SUB-06-20-5863; SPR-06-20-5868 Subdivision/Site Plan Review 10760 S. 700 E.

SANDY TOWNHOMES

PRELIMINARY PLAT

RECOMMENDATION FOR PRIVATE LANE

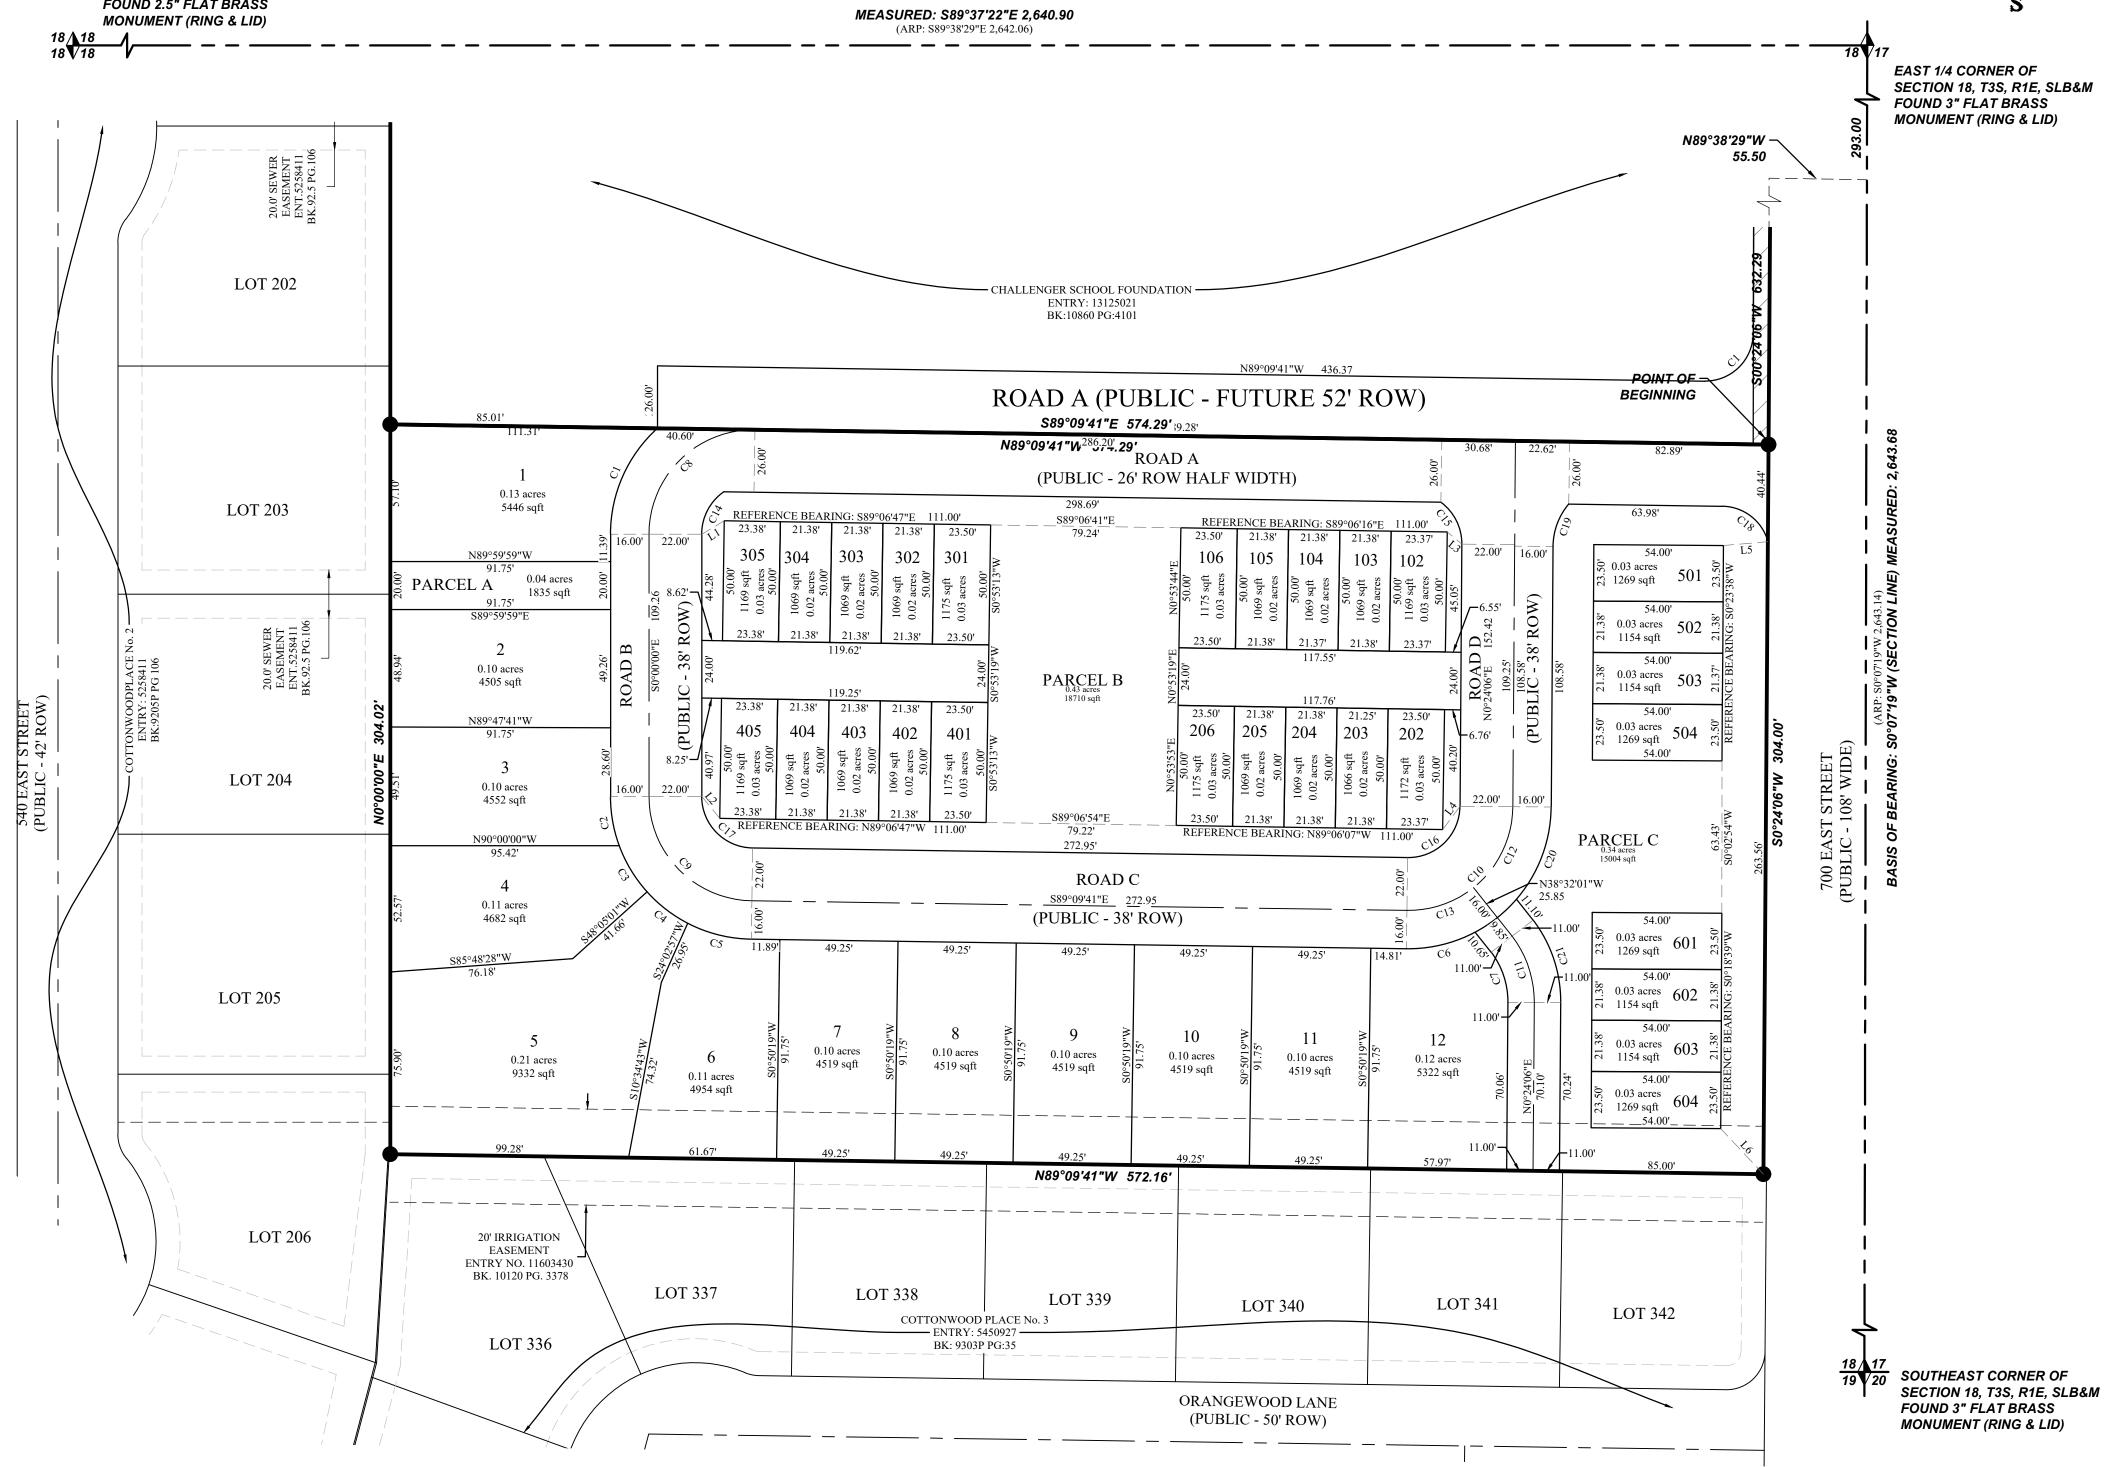
- 1. Request for "Row Width Less Than 52 Feet". This road system will better serve this community for the following reasons: Originally our plan was to have this main access road be a private road. In speaking with Ryan Kump (City Engineer) and discussing fire truck access it was determined that it would be best to have this road be a public road and function better for truck access versus creating a "turnaround" or "hammerhead". This road system will better serve this community for the following reasons:

- a) Originally this road was planned to be private road. In speaking with Ryan Kump (City Engineer) it was determined that they city prefer this to be public road so that the city can provide maintenance and/or replacement as needed for the future of this project. Concerns were raised that the city has issues with other developments where damage is not maintained or repaired properly and the city receives many complaints from residents of private developments but cannot provide assistance. Designating this will allow the city to provide snow removal, asphalt repair & maintenance etc as needed.

- b) Better access and movement for fire trucks and emergency vehicles. Designating this road as "public" versus "private" allowed for full truck movement throughout the site. Not doing this would force fire trucks to either come to a "hammerhead" or "turnaround" point which greatly inhibit fire truck movement and accessibility.

- c) In agreeing to accommodate the city's request to make this road "public" versus "private" we asked the city to compromise and keep our road width as originally designed. The reduction in width only removes the sidewalk and landscape strip from one side of the road, which is not needed for the site.

- d) Adding back the sidewalk and landscape strip actually create an unsafe pedestrian path within the community.
 - e) This road originally had straight 90 degree turns at each of the corners. We have changed these to be rounded turns and with a greater turn radius than what is needed not only for emergency vehicles but also easier for resident vehicles to navigate. Again we are still maintaining the same 27 ft of "road" required for "public" roads. We are only reducing the "Row Width" because we are requesting to remove the sidewalk from one side of the road way.

- 2. Park Strip and Side Walk Waiver to have on only one side of the street. This request will make the community safer. There is no need to have sidewalk on both sides of the street in this application. We request this waiver for the following:

- a) By removing the sidewalk from the "rambler" units we are removing pedestrians from areas that residents would be backing up and out from their garages. This makes it safer for pedestrian path and walkability on the other side of the road where there are no garages and no cars.

- b) Per city recommendation we have moved the "Playground" from the back Southwest corner and relocated it to the middle units and open area central to the entire site and much more usable for the residents. Pedestrian path now leads to the center of the site and not outward or across the "rambler" units, again making this safer for the community.

3. Subdivision with Less than 2 points of ingress/egress.

- a) We have worked directly with the city planning department and the city engineer to address this issue.
- b) The current design of a dedicated public road coming off of 700 East between the townhome site and the school was suggested to us by the city engineer. The dedicated public road gives the residential units two points of access onto a public street.
- c) To create additional access for safety and emergency, and at the request of the planning department, we have entered into an agreement with Challenger to have a right away across the Challenger property for emergency access ingress/egress as needed.

Recommendation for approval of these requests is based on the following points.

- The project only has access to 700 East. Previous development to the south, west, and north provided no stubs to the site. Due to UDOT access spacing restrictions on 700 East, a major arterial street, multiple access points to 700 East are not feasible nor advantageous from a safety perspective. Engineering believes the current design with a looped layout is the most efficient configuration. The single access pinch point is short in length, under 100', before the development opens into the proposed loop system. This avoids single segment dead ends and multiple access points to 700 East.

- The proposed cross-section is 38' of ROW. This is the narrowest public ROW width the city has approved for previous developments. This is viewed as preferrable to a private network with no park strips and sidewalks. This width allows a full-width road of 32' Top Back Curb (TBC) to Top Back Curb. In addition, an adjacent 6' sidewalk on one side of the street is included as public ROW. This cross-section was previously approved at a similar development, The Villages at Sandy. (approx. 9200 South 800 East) The proposed Thackeray Towns is similar in zoning, scope, and product, and desires to match the approved ROW found at The Villages at Sandy.
